engine mount recall

GENERAL MOTORS CORPORATION

December 10, 1971

CHEVROLET DIVISION
1970 LIGHT DUTY TRUCKS

FIGURE 1

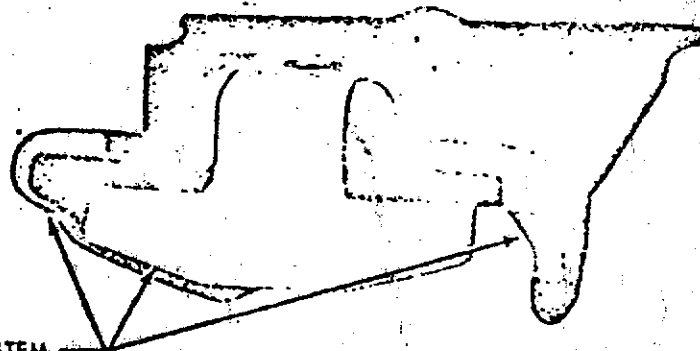
Basically on passenger cars, the modification will be the installation of restraining cable units (Figure 1) that will limit engine movement in the event of mount separation. On truck models, the modification will be the addition of metal straps between mounts and frame brackets. Parts are being processed and unitized and should become available in February, 1972, at which time a supplement to this bulletin concerning the installation of applicable cable, metal strap and/or mount units will be issued. Some few engine applications will still require the installation of interlock mounts or a combination of the interlock mount and cable. These are as follows:
